বিষয়: Diversion of 466.592 ha forest land in favour of Airport Authority of India Kota for construction of New Green Field Airport Kota, District- Bundi in the State of Rajasthan-reg.

Site inspection report for diversion of 466.592 ha of forest land in favour of Airport Authority of India for construction of New Green Field Airport Kota, District Bundi in the state of Rajasthan.

Proposal No: - (FP/RJ/OTHERS/150590/2021)

Some of the proposed CA Sites:

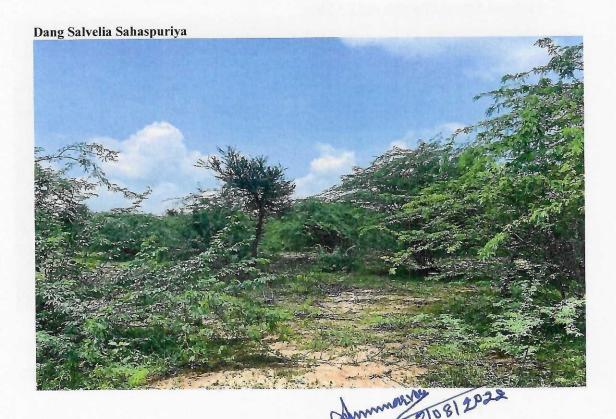
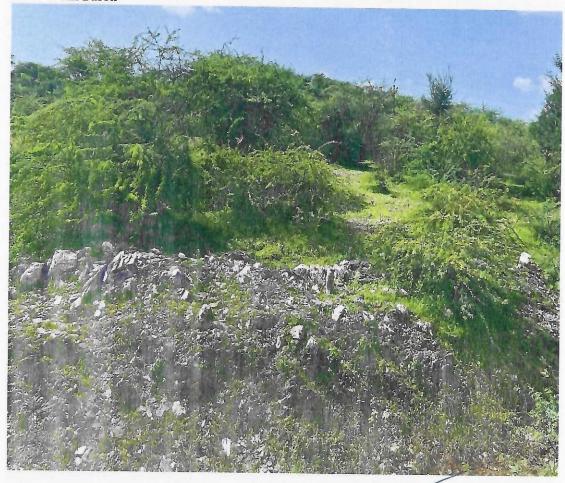
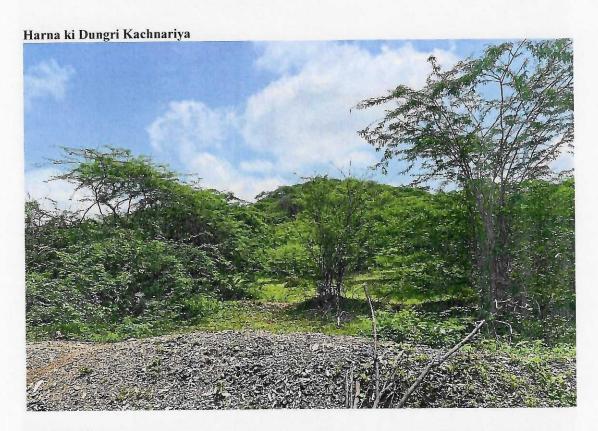
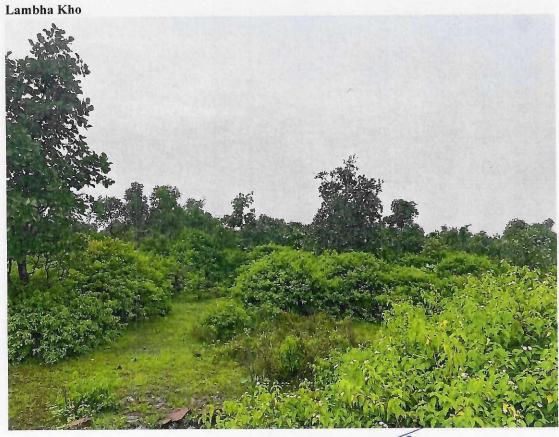
- All CA land infested with Prosopis juliflora and Lantana. There is no provision seen for removal of these invasive species in CA plan. Without removal of these invasive weeds it will be difficult to plant 1000 seedlings/hectare.

- Required Wildlife clearance from the NBWL may be taken. 11.
 - Wan L The proper provision for removal of Prosopis juliflora and Lantana has to be incorporated wherever necessary in CA plantations.
